MEMORANDUM

Re: **The Malvern School Properties, LP
Height Variance and Bulk Variances**
982 Georgetown-Franklin Turnpike
Block 28010, Lots 57 & 58
H-C Highway Commercial Zone

Date: March 22, 2023

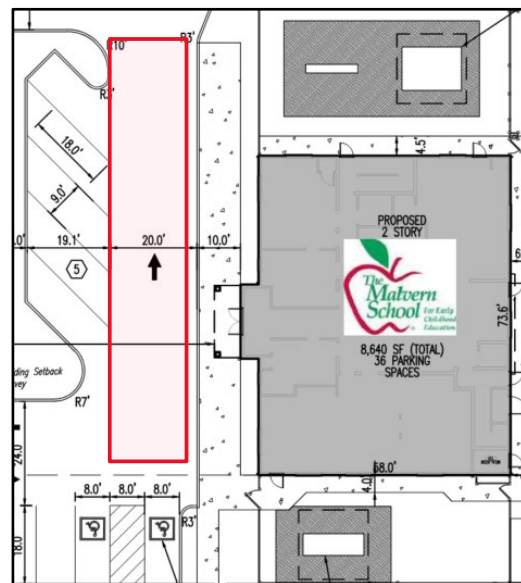
4.3. Off-Street Loading Area for Children Attending the Child Care Center: *Additional information is required.* Pursuant to §16-4.12g.5, *adequate area shall be provided for the loading and unloading of children, which shall take place on site and not in the public right-of-way.* The image to the right (the red rectangle was included by this office) indicates a

a 20-foot wide drive aisle which may be the proposed loading area for child drop off, however, it is not indicated on the plan. **The applicant should testify as to**

whether this is the “loading area” as required in the ordinance, and if so, it should be labeled on the plan.
